**SUBJECT: RECALL R09PE VANDAL LOCK STARTER INHIBIT
NONCOMPLIANCE**

R09PE

Vandal Lock Starter Wiring

MODELS AFFECTED: 2003-2010 All American Rear Engine models with Vandal Lock Options

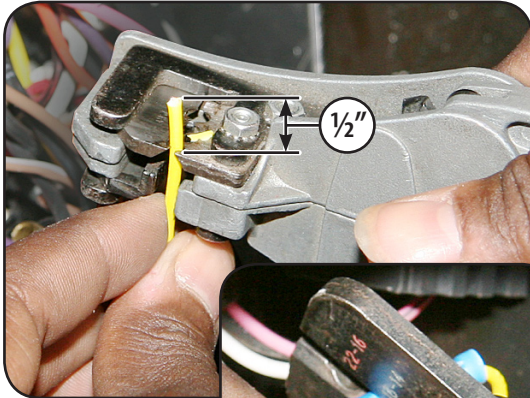
3.4 Pull the relay box forward, turn it around to access the rear cover. Remove the cover by pushing in the gray locking tabs located on both sides of the box.

3.5 Locate 16 gauge purple wire **1008**, that runs to the IGN dropout relay (4th down on left). Cut wire **1008** and tape the stub wire at the relay.

3.6 Locate 18 gauge yellow wire **1009**, that runs to the Vandal Lock Relay (5th down on right). Cut wire **1009** about 4 inches back from the relay.

Typical Wire Splicing

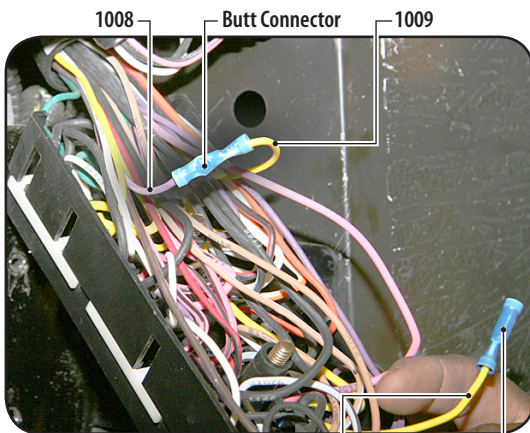
4" Yellow Wire from Vandal Lock Relay
Splice to new loomed wire provided.

3.8 Strip the 16 gauge loomed wire provided (BB #01871300) and the 4 inch yellow 18 gauge wire coming from the Vandal Lock Relay (referenced in step 3.6) 1/2 inch from the ends. Splice wires together using butt connector provided (BB #00036507).

Wiring Access to Chassis

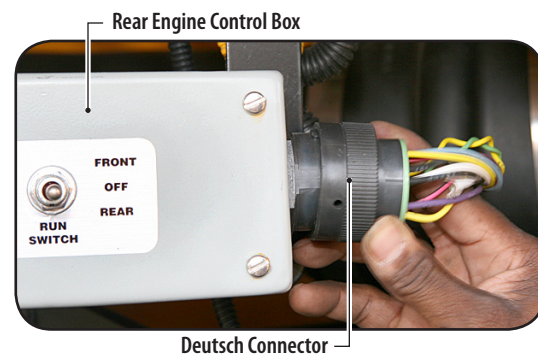
3.9 Pry back insulation material below relay box to create an access to the chassis for routing free end of 14 gauge loomed wire to the rear of the bus.

3.10 Insert free end of loomed wire thru the access created in step 3.9 and feed through the remaining wire.

Deutsch Connector

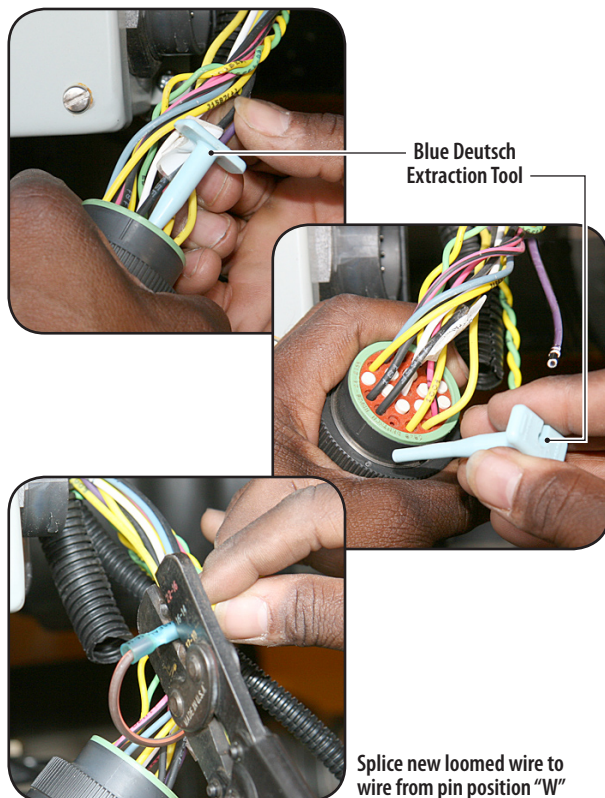
5.1 Remove Deutsch connector from the Rear Engine Control Box. Locate pin positions "X" and "W".

5.2 Remove the wire in pin position "W" using blue Deutsch extraction tool provided with parts. Cut off the terminal and strip wire 1/2 inch from the end. Splice to the new wire that was run through the chassis, using butt connector provided (BB #00036507).

5.3 Remove the wire in pin position "X" and place in pin position "W".
